**COUNTY OF SAN MATEO
PLANNING AND BUILDING DEPARTMENT**

DATE: November 9, 2018

SUBJECT: Consideration and approval of a detailed landscaping plan for the Ascension Heights Subdivision approved on appeal by the Board of Supervisors. The project is located in the unincorporated San Mateo Highlands area of San Mateo County. A condition of approval requires the applicant is to submit a landscaping plan for review and approval by the Planning Commission, including a 30-day public review and comment period before recordation of the Final Map.

County File Numbers: PLN 2002-00517
(San Mateo Real Estate and Construction)

**40' SCALE
 LANDSCAPE
 PLAN
 SUMMARY**

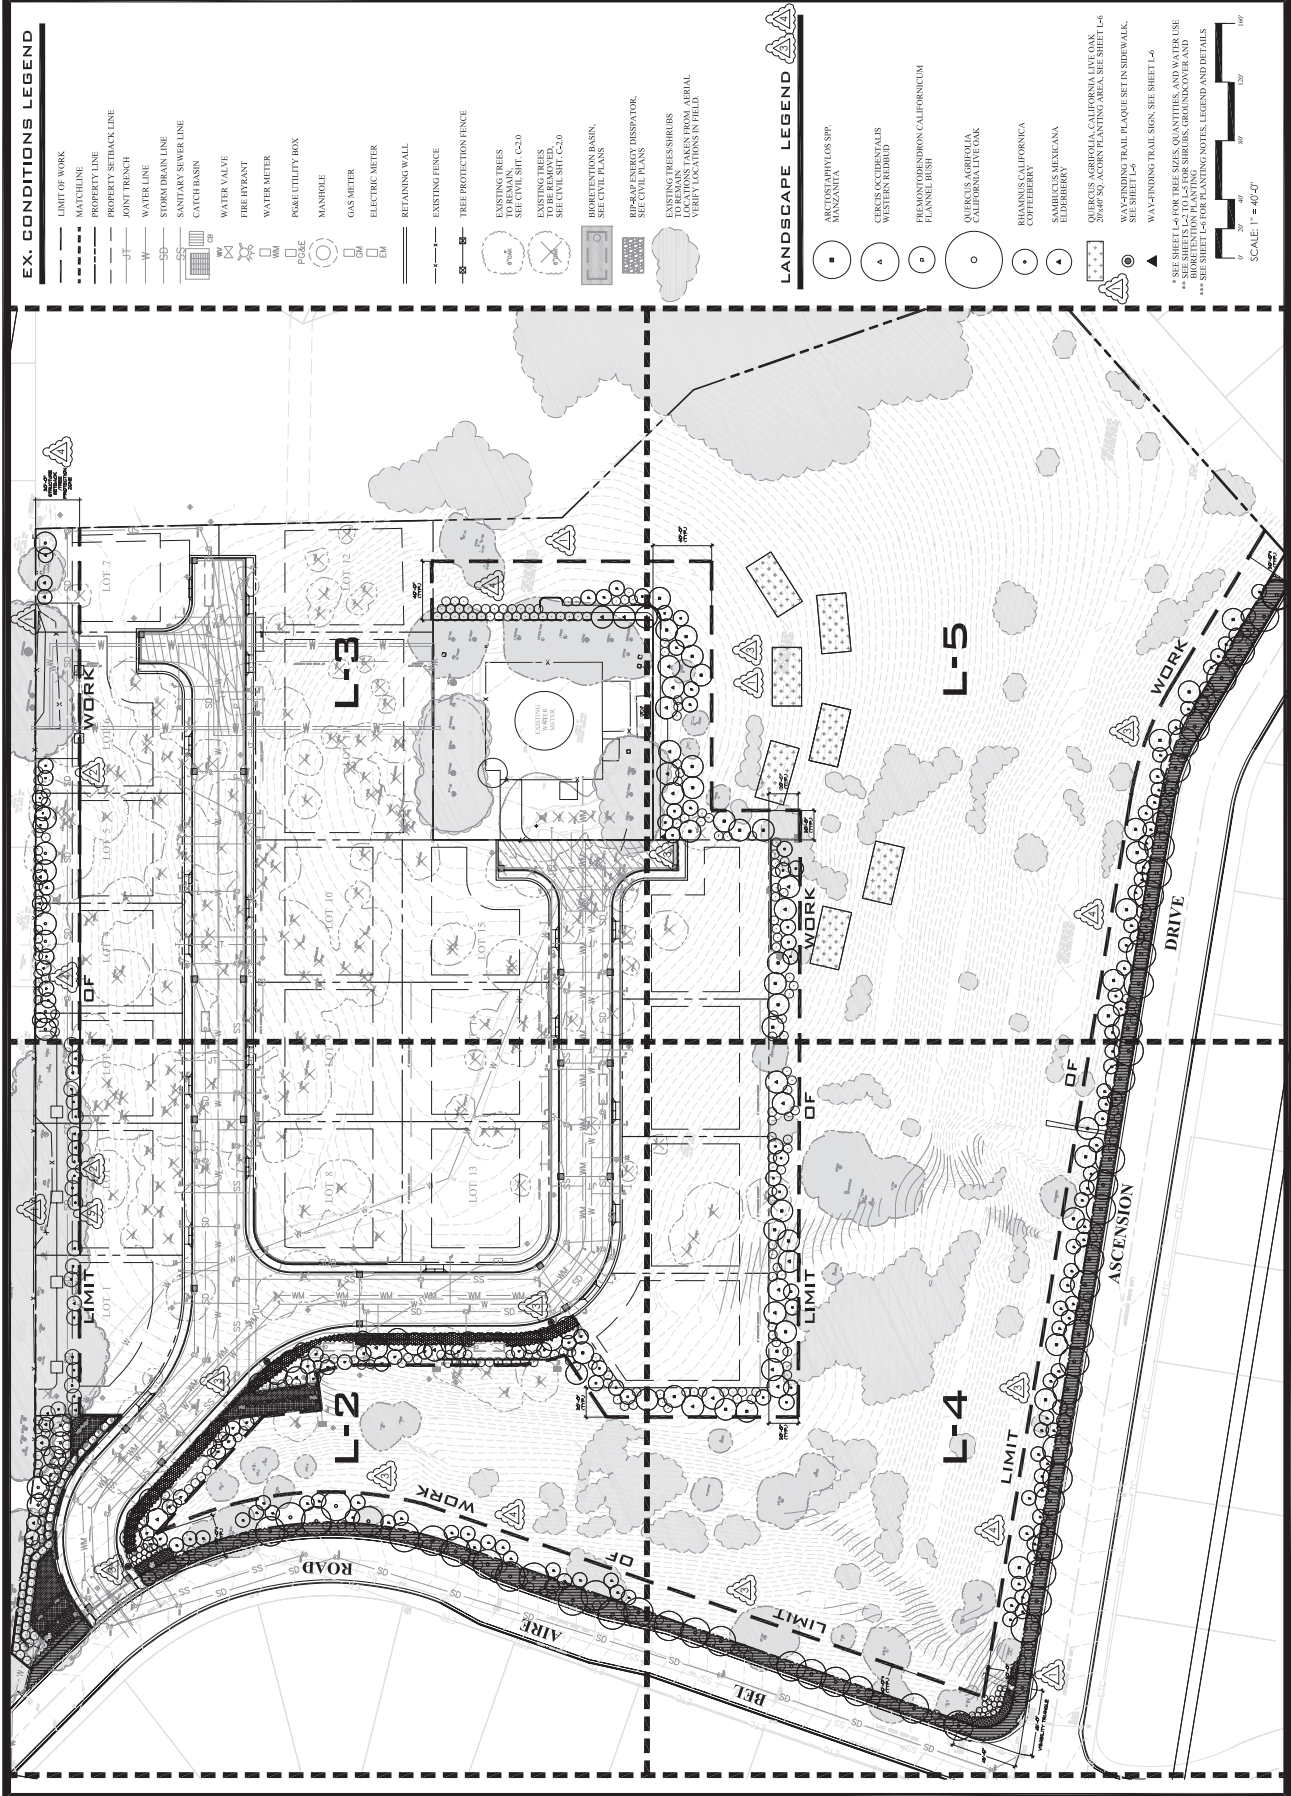
The back of Lots 1, 2, and 3 have trees growing on the project-side of the property line. The plan shows a tree protection fence approximately 15-feet from the property line. It also shows numerous planting just outside of the tree's protection zone.

The subject trees' roots are not likely found in abundance on the uphill slope due to the trees being located in a basin where water would naturally accumulate. The landscape plan details for a 10-foot TPZ. An acceptable TPZ for these trees is a minimum of 25% of the total canopy area. 25% is the maximum allowable root loss a tree can sustain without compromising its long-term health and stability. Because the radius of the canopies is approximately 40- to 50-feet, 50% of the total area would yield a radius of 28- to 35-feet, which would be 25% on the project-side of the root area. These numbers are conservative as only one side of the tree has the potential to be affected by construction activities which would be, arguably, 25% of the total area. However, a TPZ less than the above distances may have the potential for the critical root structure to be compromised and would result in a loss of stability. This area of TPZ is for construction only.

No planting should be installed within the area beneath the driplines of the trees for Lots 1, 2, 3 6 & 7 as the plantings will introduce unneeded competition. However, the screen trees are acceptable. Planting of native ground vegetation may be placed anywhere outside of the dripline of any tree designated to be preserved, whether on or off the property, and within this 30-foot structural setback/tree protection zone.

The 30-foot setback is also our recommended TPZ for trees along the perimeter of Lots 1, 2, & 3 for the construction-period only.

Fencing for the TPZ for the subject trees are to be set at the 30-foot structural setback and encompass the driplines of the trees at the very minimum.

**PROTOTYPICAL
 REAR YARD
 LANDSCAPE
 LOTS 2 AND 5**

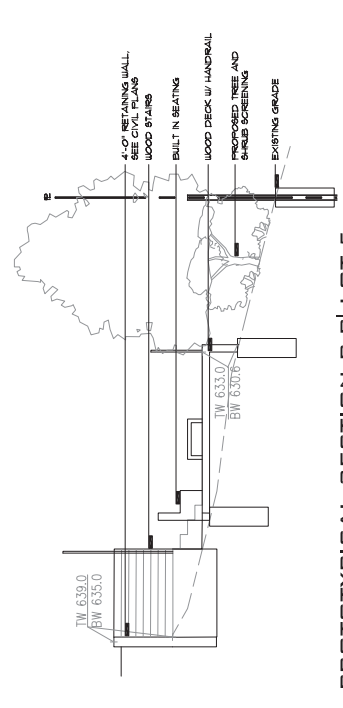
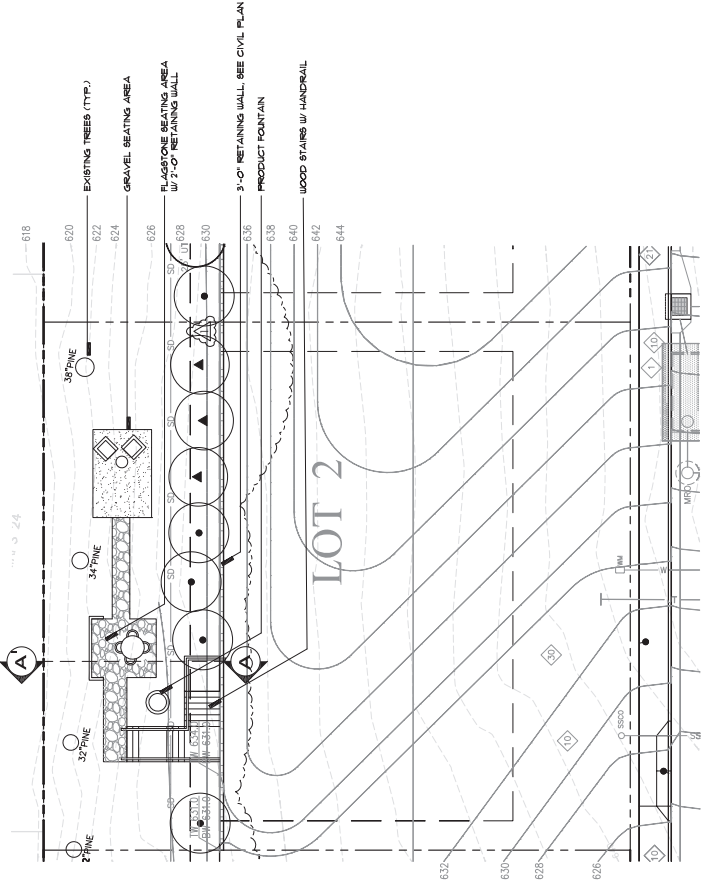
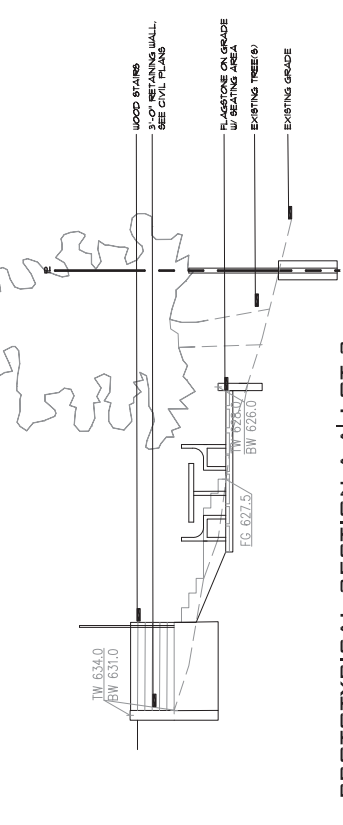
As part of the detailed landscape plan, the applicant has also provided a list of landscape improvement inclusions and exclusions to be incorporated into the Covenants, Conditions & Restrictions (CC&R). These landscape improvement inclusions/exclusions will clarify to future property owners, and the homeowners association the type of improvements they will be allowed to install in their rear yard, not including any structures as defined in the County's regulations; i.e., a "structure," is any ground level structure greater than 18 inches in height above grade. Items listed for inclusion include plantings and irrigation, on-grade flagstone, concrete patios and/or wood decks below 18 inches in height, landscaping elements no larger than five (5) feet wide and five (5) feet tall (i.e. fountains, pilasters, pilasters, decorative landscaping elements), movable and non-attached/ anchored landscaping furniture, and 12-volt lighting. A prototype sample of two scenarios are included as part of the detailed plan on page LP-1.

Staff believes the proposed items listed, as constrained are appropriate given that they don't constitute a structure by definition.
